Service Bulletin

#A-103

B-Series Heaters

Replacement of 42D36 Switch Series

FIGURE 1

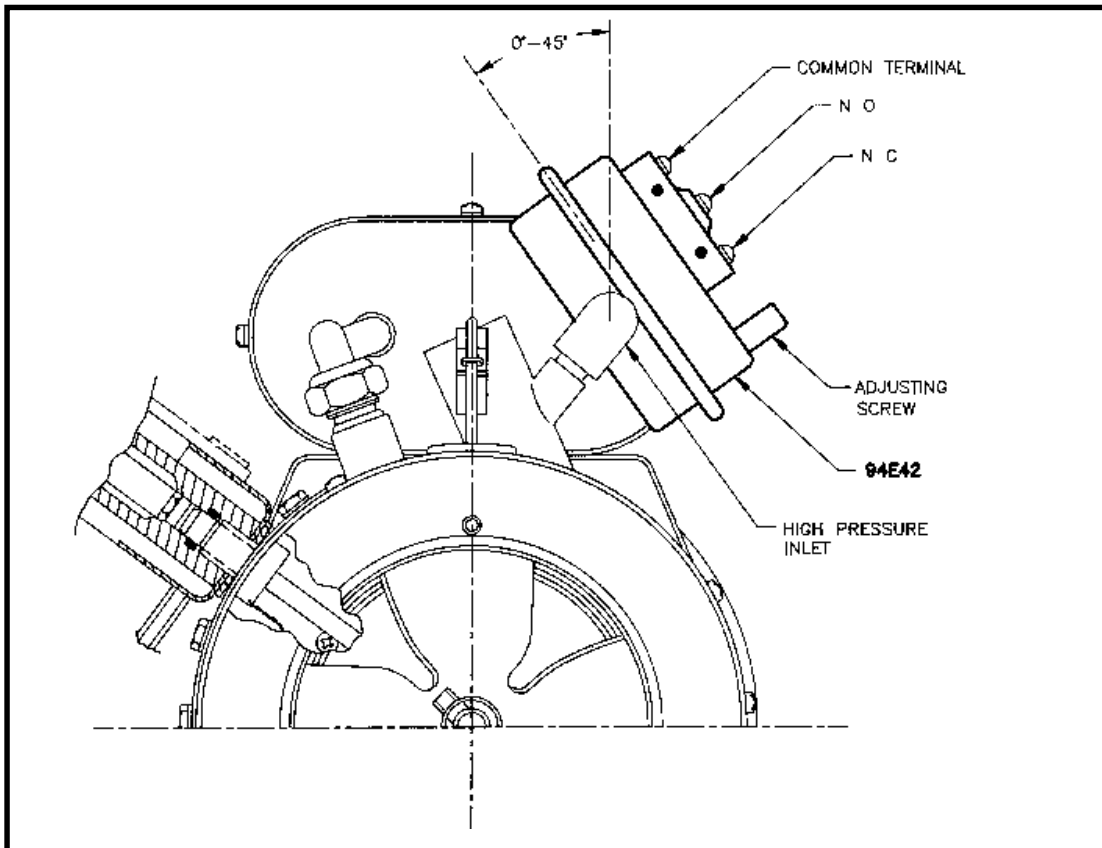
- 2.2 Install the new 94E42 Switch in place of the removed 42D36 Switch and reconnect all electrical wires and sense lines exactly as previously connected - combustion air inlet to HIGH pressure port and sense line to LOW pressure port. NOTE: the new 94E42 C/A Switch mounts as shown in Figure 1 of this Bulletin and has the high pressure port and adjusting screw reversed from the old 42D36 Switch - that is intentional.**
